STAFF REPORT

SUBJECT: H-2021-0085

Meridian U-Haul Moving and Storage

Request for a Conditional Use Permit to allow self-storage, vehicle and equipment rentals with outdoor display, and ancillary retail on 6.86 acres in the C-G zoning district, by Gurnoor Kaur, Amerco Real Estate Company. A Development Agreement Modification regarding this development was approved by the City Council on February 3, 2022.

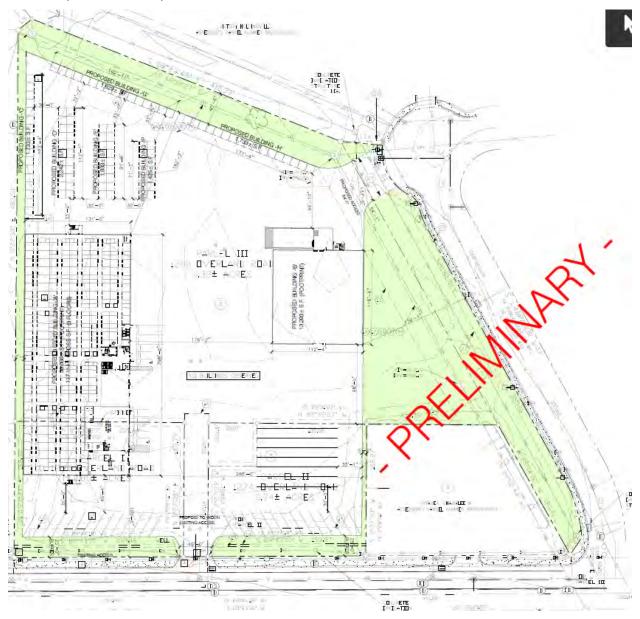
Overall, staff does believe the combination of materials, colors, canopies, columns and fenestration results in a storage facility that is of higher quality. However, staff believes there could be some elements that do not meet the requirements of the Architectural Standards Manual (ASM). ASM 3.1B requires buildings to have horizontal modulation every 30 feet or 50 feet, depending on whether the building is greater than or less than 150 feet in length. Based on the site plan, staff is unsure all sides of the buildings visible from a public street meet modulations requirements. Also, ASM 3.2A requires for at least 30% of applicable façades use any combination of concrete, masonry, stone, or unique variation of color, texture, or material, at least 10-inches in height, around the base of the building. Staff is also unable to ascertain if this is satisfied. Complete design review will occur at time of Certificate of Zoning Compliance.

Due to the high visibility of this project from E. Overland Rd. and the existing residences at the south, staff believes there should be additional design considerations. Staff has concerns with the exposed stairs on the south side of Building A both for visual impacts and potential maintenance issues with these stairs being exposed. Staff recommends either the stairs be removed from southern and eastern locations visible from E. Overland Rd., or screened in a stairwell or similar architectural element comprised of materials consistent with the exterior field materials of the building. Also, staff recommends the roll up doors on the south and east sides of Building A and south side of Building be better integrated into the building design through use of color, architectural detailing, overhangs, door frame treatments, etc. Also, the applicant has only submitted elevations for Buildings A & B. Full elevations of all four sides of all eight buildings will be required at time of certificate of zoning compliance and design review.

- 7. The elevations prepared by A&M Associates on December 3, 2021 shall be modified as follows:
 - a. All stairs that are visible from E. Overland Rd. shall be within the building or screened in a stairwell or similar architectural element comprised of materials consistent with the exterior field materials of the building.

- b. Roll up doors that are visible from E. Overland Rd. shall be integrated into the building design through use of color, architectural detailing, overhangs, door frame treatments, etc.

- 8. Elevations for all four sides of all buildings shall be required at time of CZC and DES. Elevations should be architecturally consistent with the approved elevations for Buildings A & B.

A. Site Plan (date: 8/12/2021)

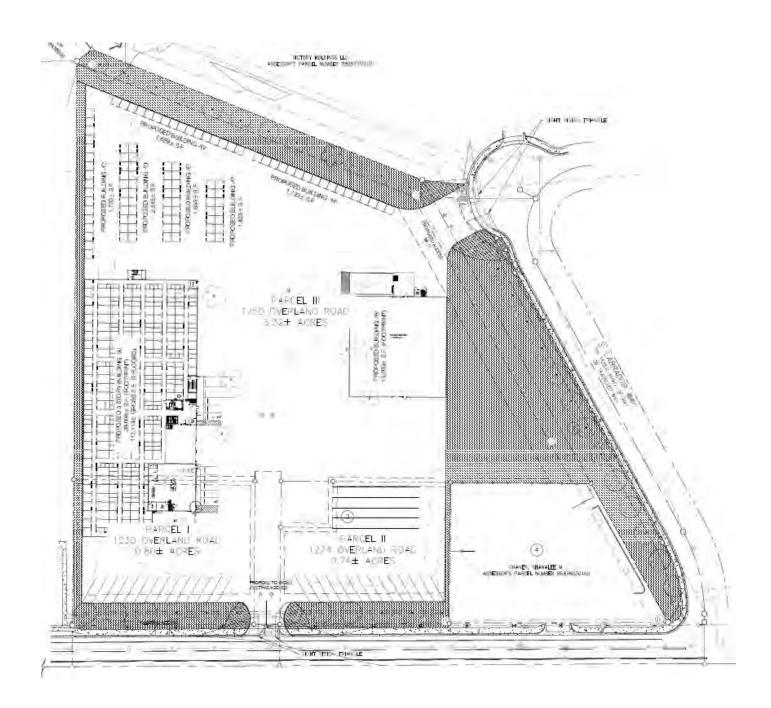
There are several buildings that do not appear to meet the minimum spacing requirement of 25 ft. This includes between the northeast corner of Building C and southwest corner of Building G, between Buildings G and H, and possibly between the northwest corner of Building A and the southern side of Building C. The site plan will need to be revised accordingly.

In addition, due to the high visibility of the site and the residential uses directly across E. Overland Rd to the south, staff has concerns regarding trailers and other associated moving equipment being littered throughout the site. Although staff believes display of operable moving vehicles is acceptable along the southern property line, as a condition of approval, staff recommends all trailers and other moving equipment be stored behind a closed vision fence, wall, or screen or within an enclosed structure and not be visible from any street. Screening fences or walls should be designed to be consistent with building architecture in accord with UDC 11-4-3-33 and details of these walls, fence or screen shall be submitted at time of CZC.

The Pack It Up Subdivision Plat allows access via a shared drive from E. Overland Rd and there is a second access proposed at the end of a "knuckle" on S. Labrador Wy. The site plan reflects these two accesses. Meridian Fire supports this configuration, and staff has not received comments from ACHD.

shown at 3,000 sq. ft., 6 parking spaces are required, whereas the site plan shows at least 26 parking spaces along the south perimeter and 10 more directly adjacent to the office.

- 3. The site plan prepared by AMERCO Real Estate, dated August 12 2021, is approved as submitted, with the revision that all buildings shall maintain at least 25 ft. of separation per UDC 11-4-3-34.
